ASSESSMENT REPORT

HUNTLEE NEW TOWN STAGE 1 MP 10_0137 MOD 5

Figure 3: Proposed modifications to sub-stage 3 (Stage 1 Master Plan)

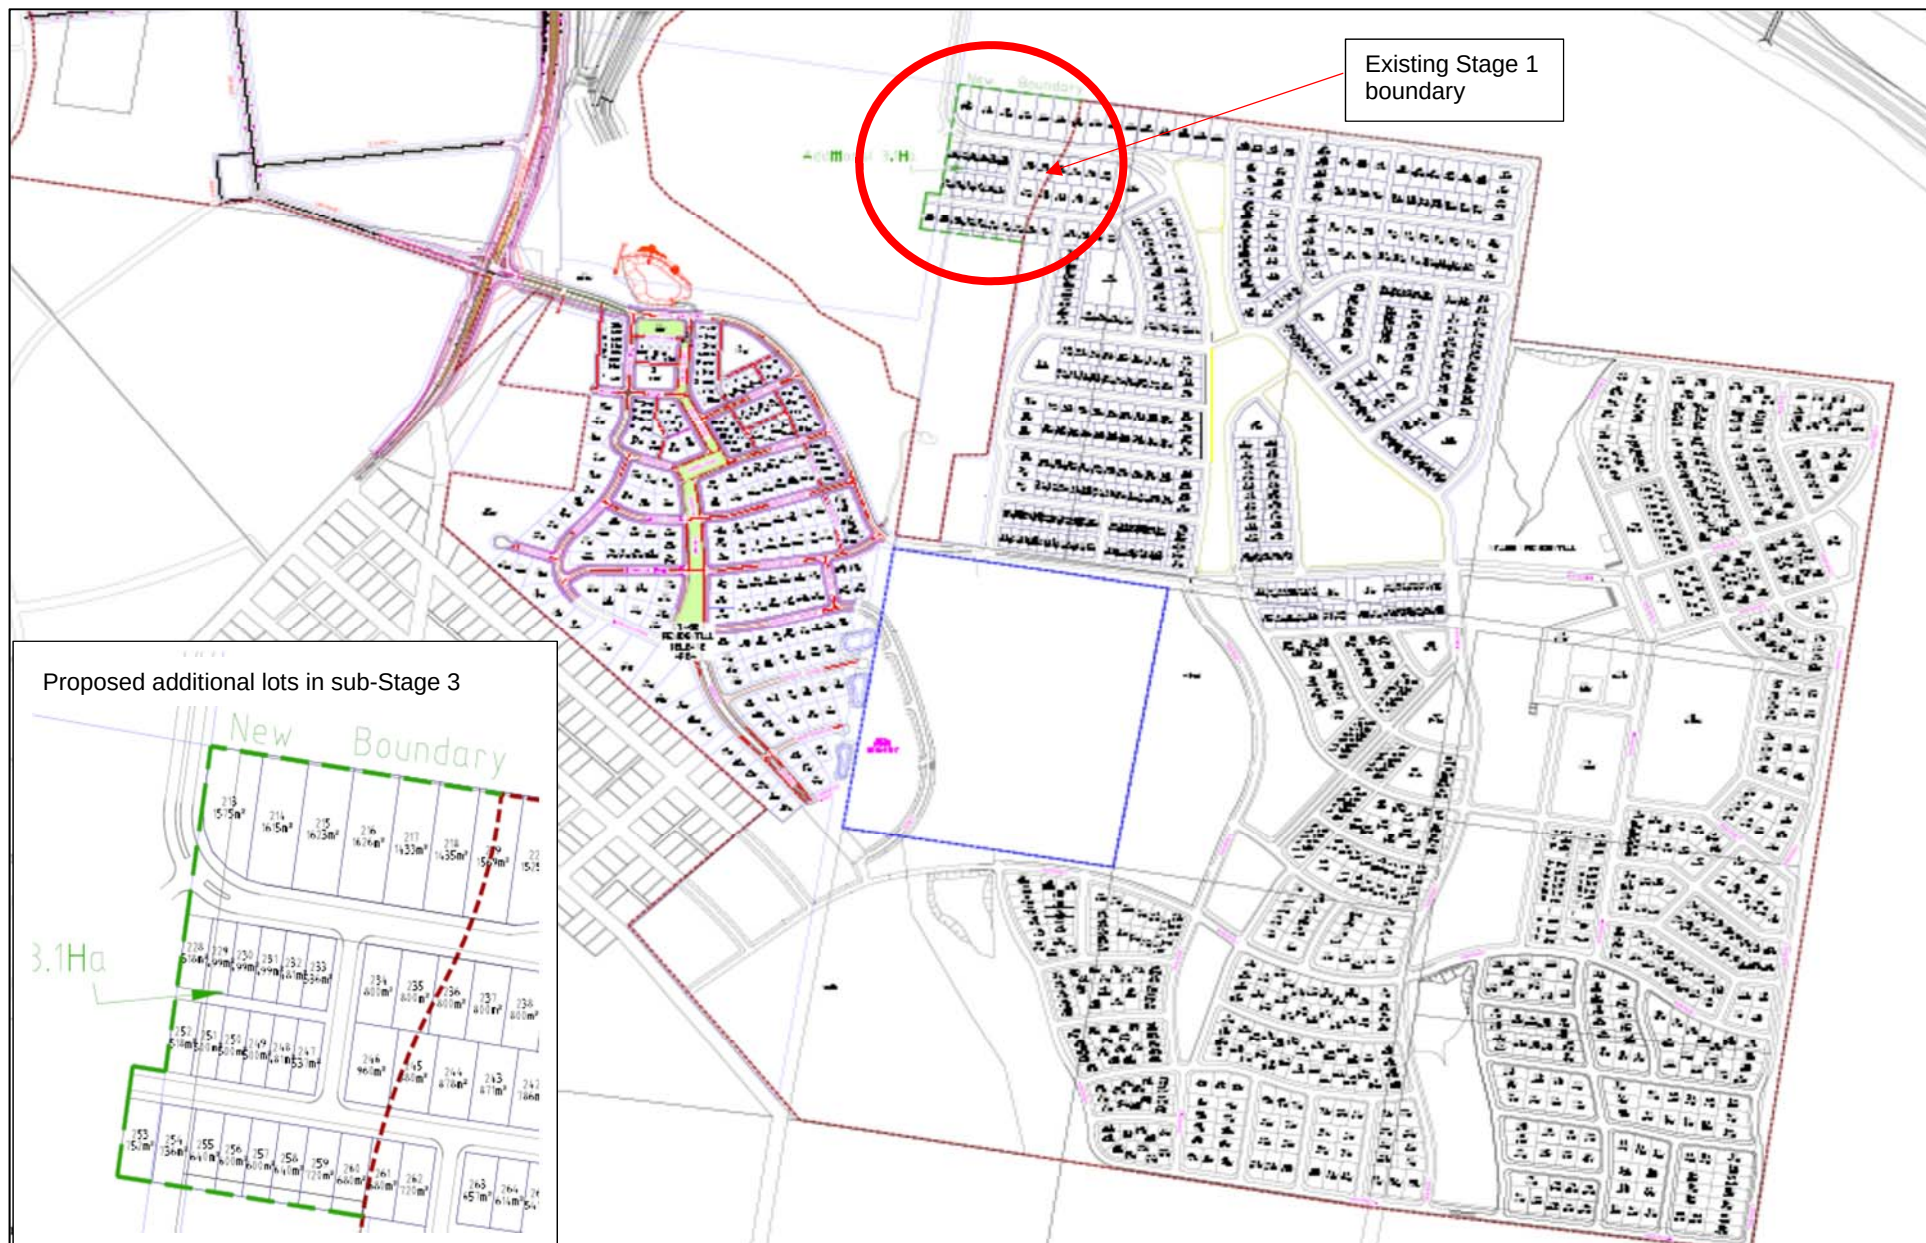
This proposal seeks approval to extend the boundary of sub-stage 3 to include 33 additional residential lots serviced by an extension of the local road network to provide vehicle, pedestrian and cycle access (see **Figure 3**). The Proponent has submitted a revised Masterplan and a revised road hierarchy plan illustrating the proposed extension of sub-stage 3.

The additional land area falls within the Huntlee DCP boundary and the DCP contemplates residential subdivision within this part of the site (see **Figure 5**). The Department considers that the extension of the Stage 1 residential subdivision into this part of the site is acceptable given residential development is permissible and the proposal would form a logical extension of sub-stage 3 of the approval.

Figure 4: Amended Street Hierarchy Plan

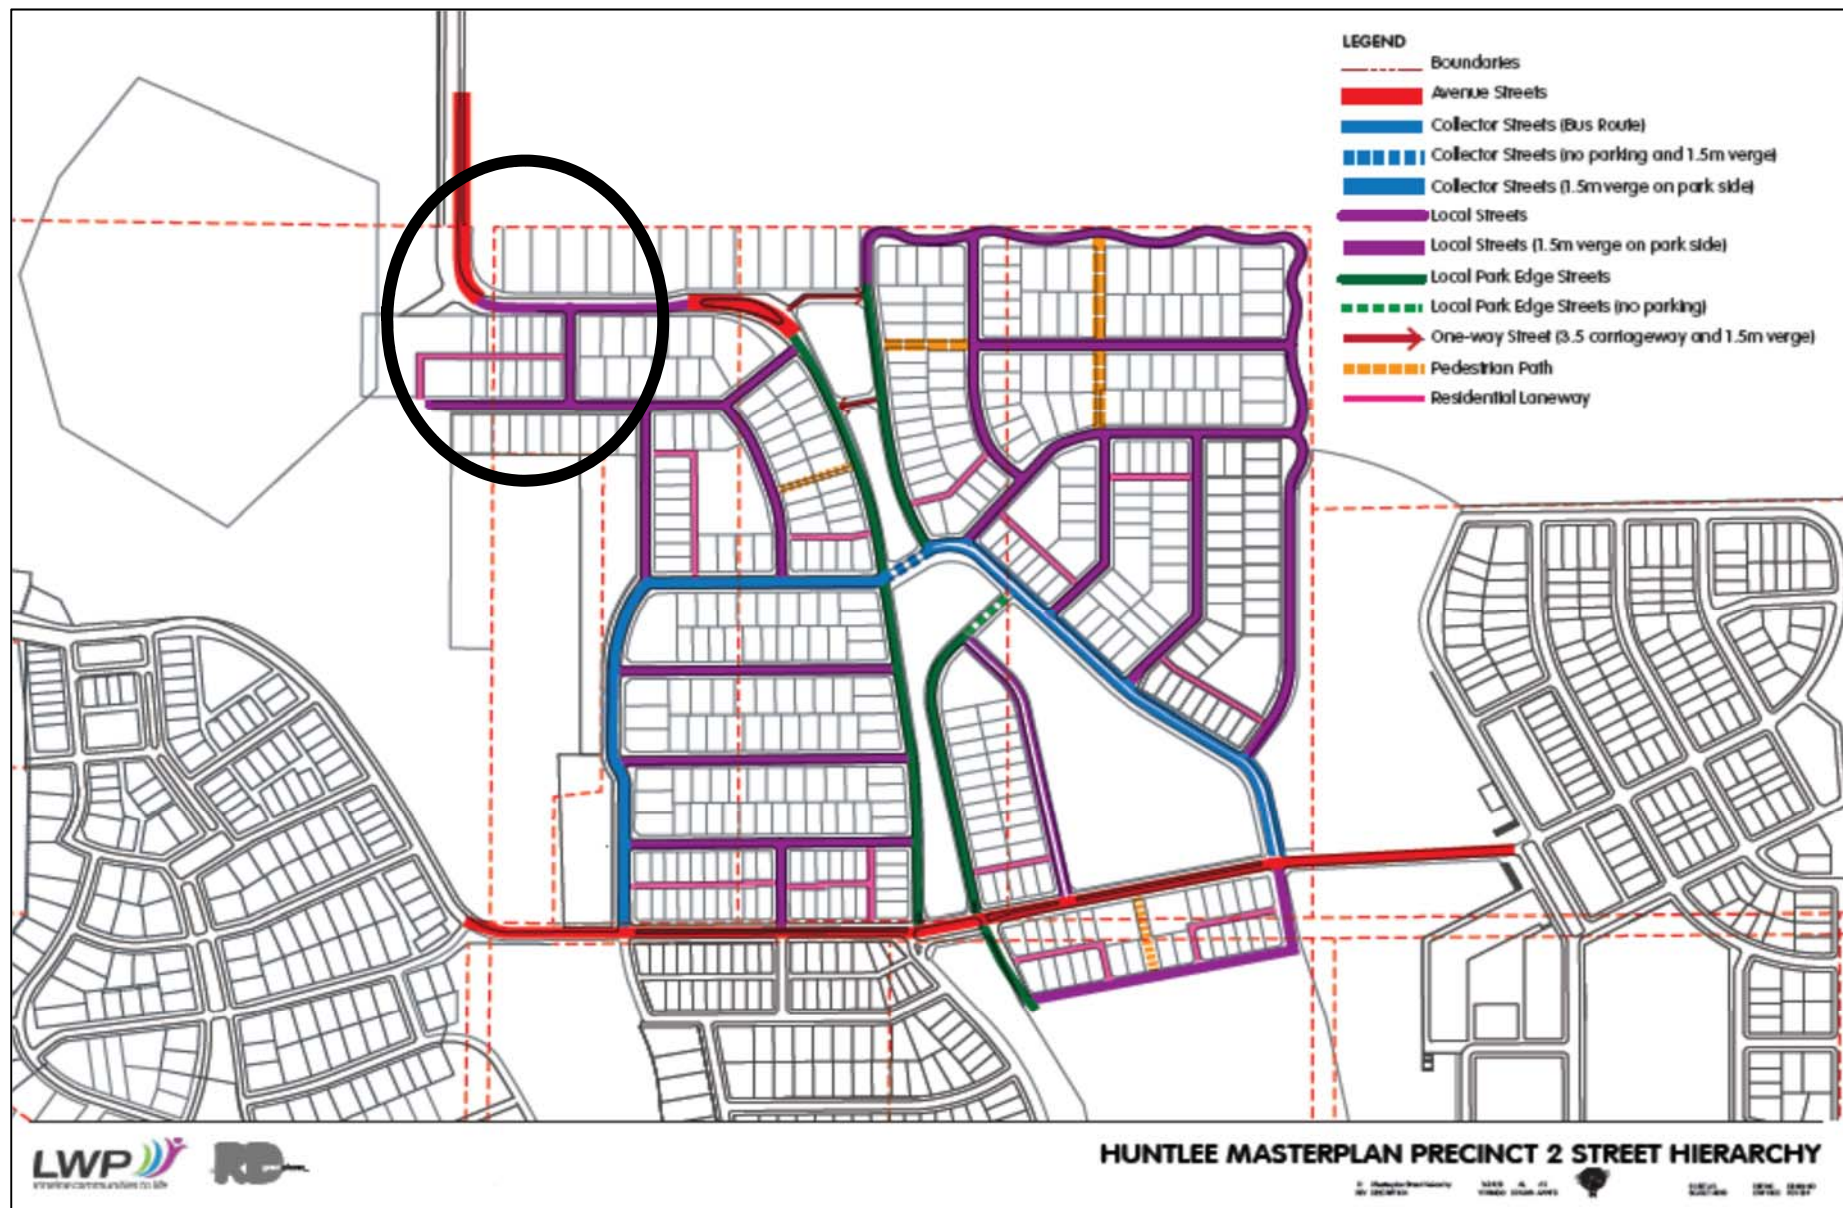
Council advised it generally supports the proposed amendments but raised concern about the proposed road hierarchy identifying road typologies that are not currently identified in the Huntlee Development Control Plan (DCP). Council also requested that a condition be imposed requiring the State and Local VPA's to be amended to include the additional land associated with the proposed modification.

Council expressed it generally supports the proposed modifications, subject to the street hierarchy being consistent with the Huntlee DCP.

The Proponent provided a response to submissions (RTS) on 2 May 2016 to address the matters raised by Council. The RTS included an amended Street Hierarchy Plan and confirmation that the Proponent has written to Council outlining its intention to amend the Local VPA to reflect the changes contemplated as part of MOD 5.

In response to Council's concerns, the Proponent provided an amended Street Hierarchy Plan which utilises street typologies contemplated in the Huntlee DCP, namely Local Streets, Avenue Streets and Residential Laneways.

The Department is satisfied the proposed extension of the sub-stage 3 road network adopts the street typologies described in the DCP and forms a logical extension to the approved road layout for sub-stages 2-5 (approved under MOD 3). Overall, the Department is satisfied that the proposed expansion of sub-stage 3 is generally consistent with the aims and objectives of the Huntlee DCP.
